**SIB 63 02 22****EXCESSIVE CONDENSATION IN THE HEADLIGHT(S)**

2025-04-25

This Service Information Bulletin (Revision 2) replaces SI B63 02 22 **dated September 2022**.

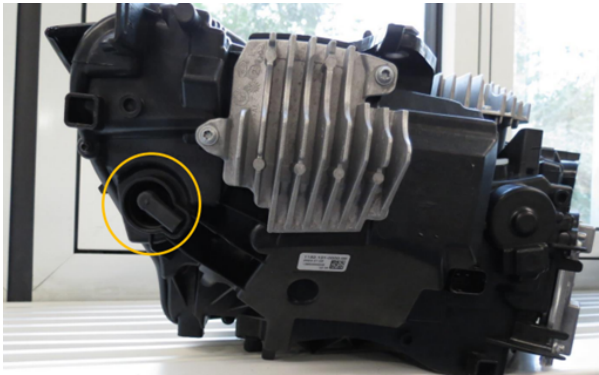
The headlight ventilation grommets may allow excessive moisture to enter the headlight.

Replace both headlight ventilation grommets with the updated part.

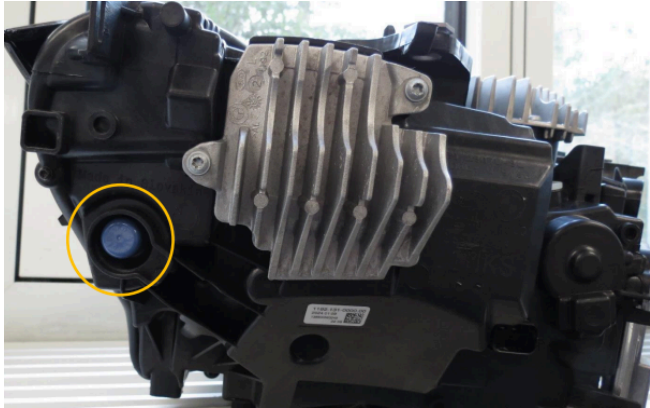
3. Using a suitable tool, remove the outer ventilation grommets from both headlights (circled in yellow).

4. Install the updated plugs on both headlights (circled in yellow).

Note: Make sure to fully seat the ventilation grommet onto the headlight.
